General Electric Company
175 Gartner Avenue, San Jose, CA 95128

Docket No. STN 52-001

Subject: Submittal Supporting Accelerated ABWR Review Schedule - DFSE
Confirmatory Items 7.2.5-1 and 7.2.5-2

Enclosed is a SSAR markup addressing DFSE Confirmatory Items 7.2.1-5 and 7.2.5-2.

Figure 7.2-1 ABWR SSLC CONTROL POWER SCHEME (SEE ALSO FIGURE 8.3-1)

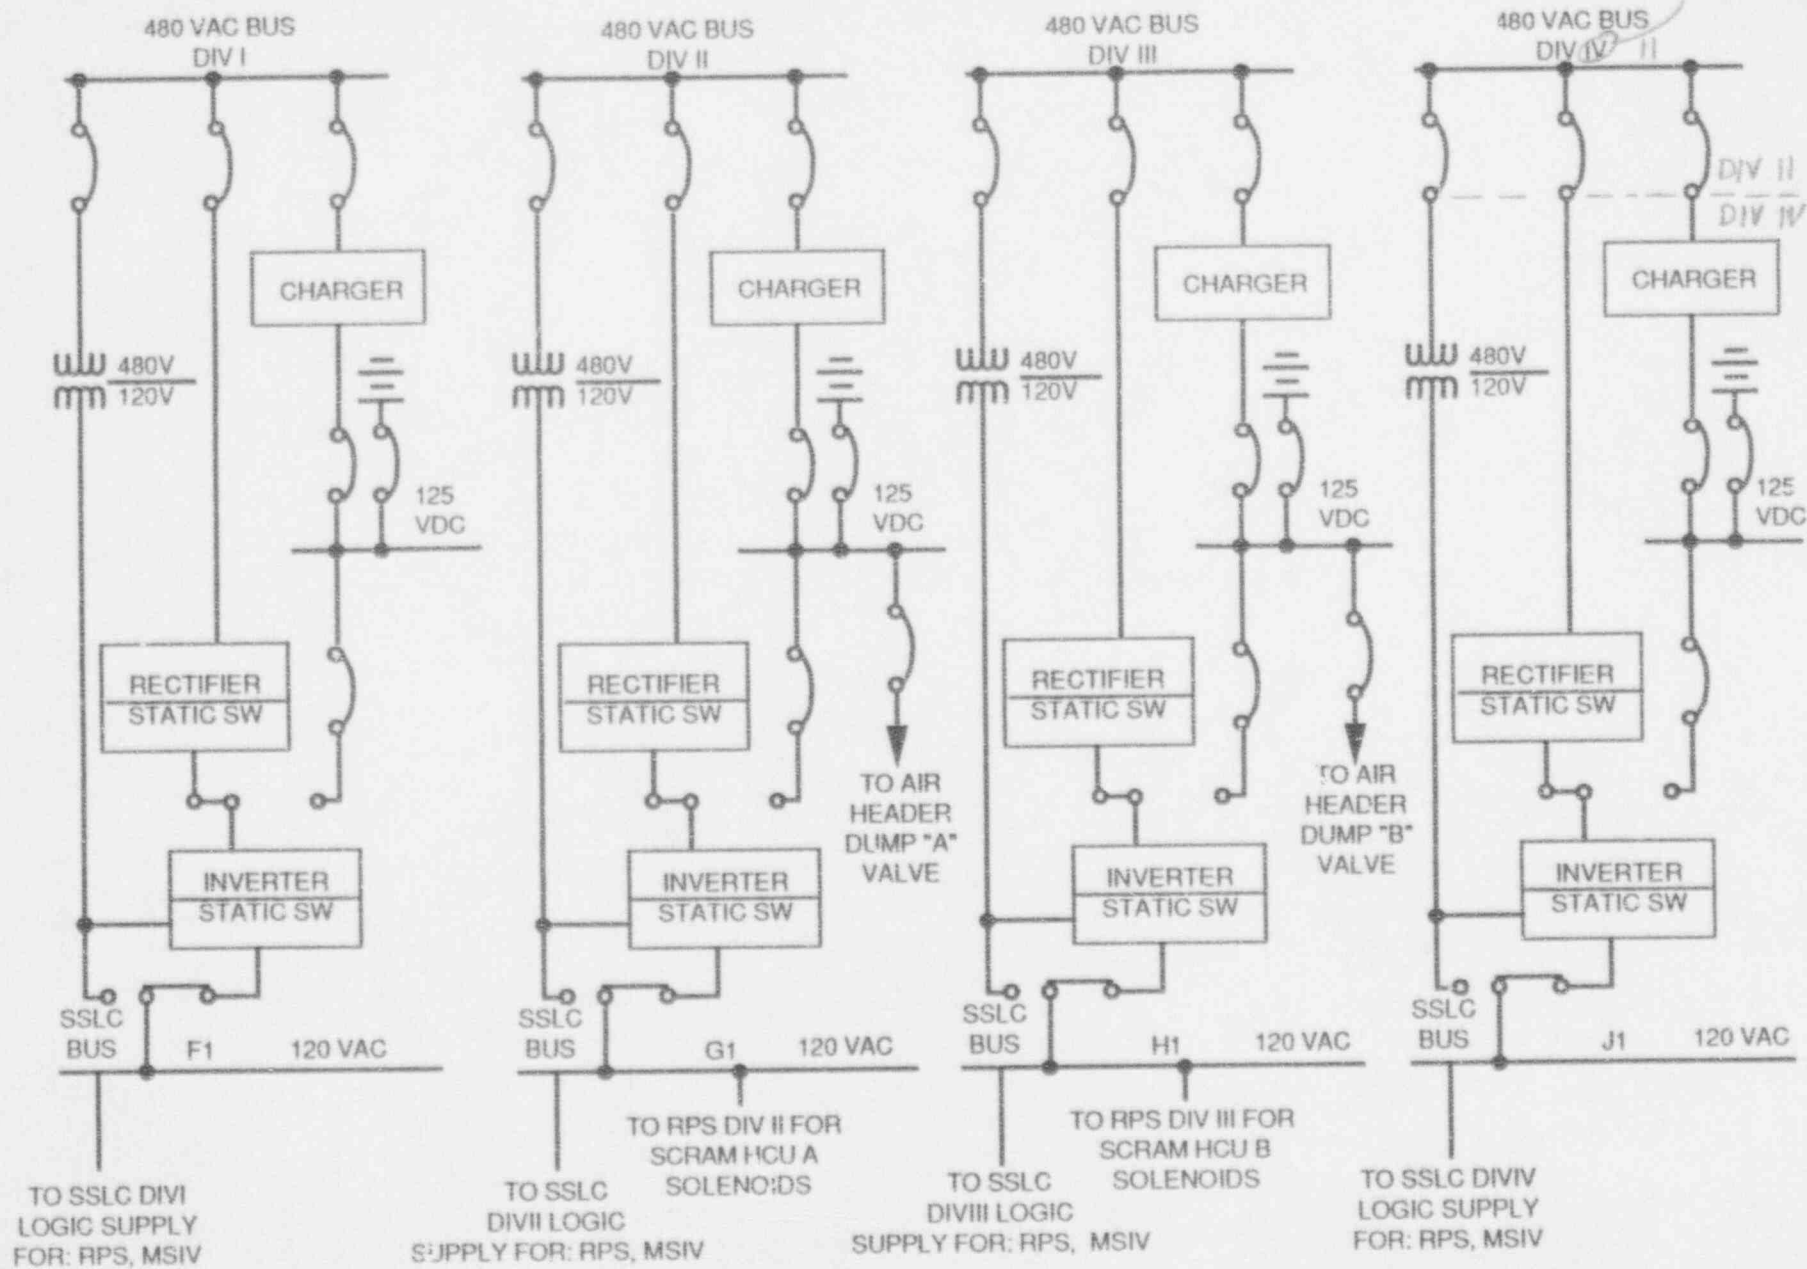
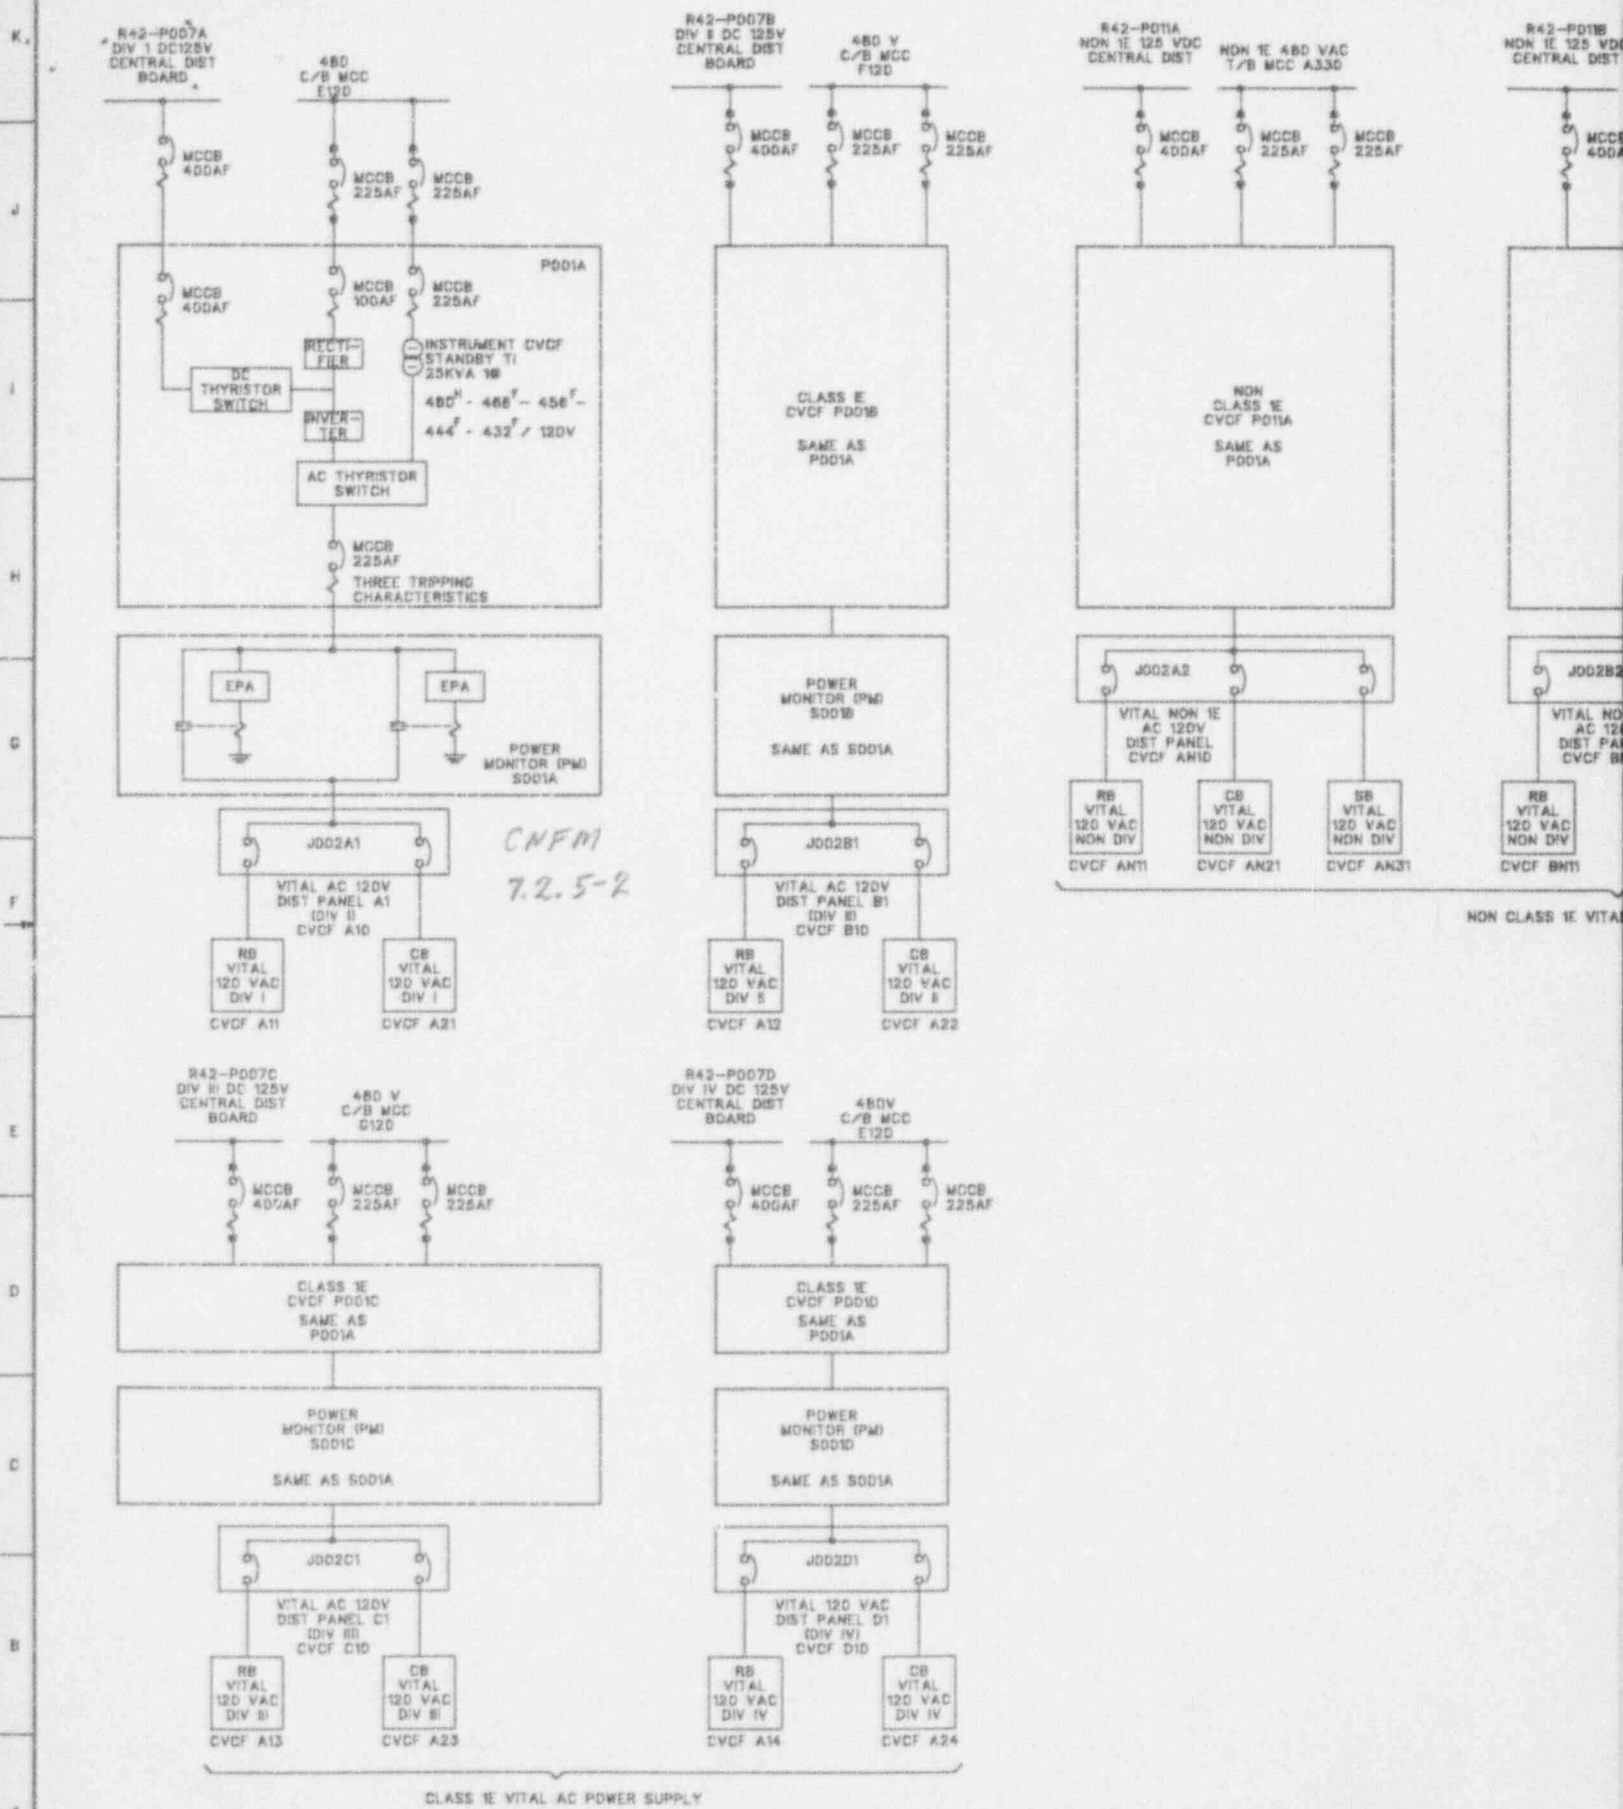
SSLC power sources are shown in Figure 7.2-1.
